From: Gardner, Larry ENV:EX
Sent: Friday, April 26, 2013 2:02 PM
To: Danyluk, Carol ENV:EX; Bourgeois, Jason ENV:EX
Cc: Stroich, Chris ENV:EX; Love, Mark P ENV:EX; Sundher, Avtar S ENV:EX; McCammon, Alan W ENV:EX
Subject: Application of TG6 - Cache Creek Landfill

Considering Closure of the Cache Creek Landfill

Thank you for meeting with Regional Environmental Protection representatives here on April 5, 2013, to discuss the Closure Period Plan submitted for the Cache Creek Landfill, and for your follow up correspondence of April 18, 2013, outlining the discussions we had on April 5, 2013. We have reviewed the Closure Period Plan and the requirements of the Operational Certificate 7577, and have identified some outstanding issues to be addressed or discussed further.

Closure Period Plan Review

FIGURE 12

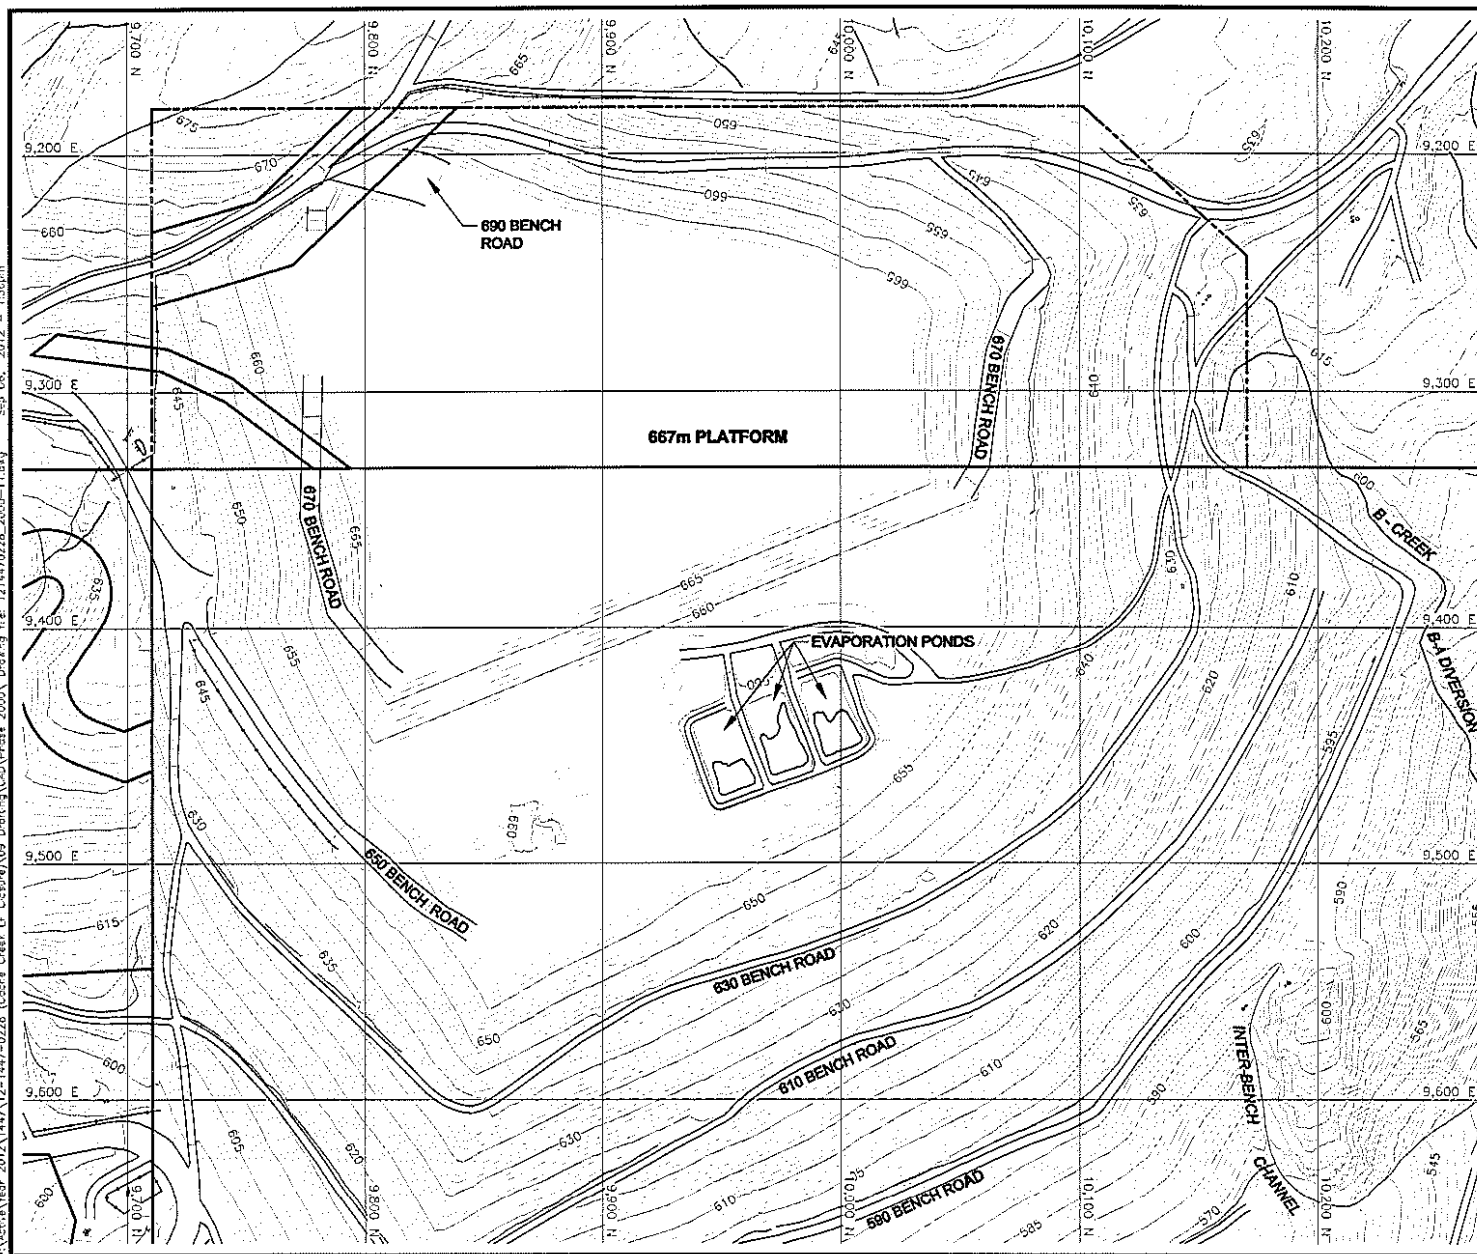
The Closure Period Plan proposes the installation of groundwater recovery wells. In further considering this proposal it is appropriate to first determine the applicable water quality standards for the site and the point of compliance at which the standards will apply. The guidance for this determination is provided by *Technical Guidance 6 on Contaminated Sites*, (<http://www.env.gov.bc.ca/epd/remediation/guidance/technical/pdf/tg06.pdf>) . You are required to retain the appropriated qualified professionals to provide a recommendation and rational in this regard. Following receipt of the above information, I will make the determination of the applicable water quality standards and point of compliance. This will establish whether groundwater collection and treatment, or alternatively risk assessment, is a regulatory requirement.

The results of the simulation to control migration by groundwater pumping are presented for the calibrated model in Figure C-12. The simulation determined that a total of four pumping well centres located east of the Landfill, each pumping at a rate of approximately 4 US gallons per minute (USgpm), would be required to manage the off-site migration of groundwater. This would result in a combined recovery rate for the well field of 16 USgpm (approximately 90 m³/day).
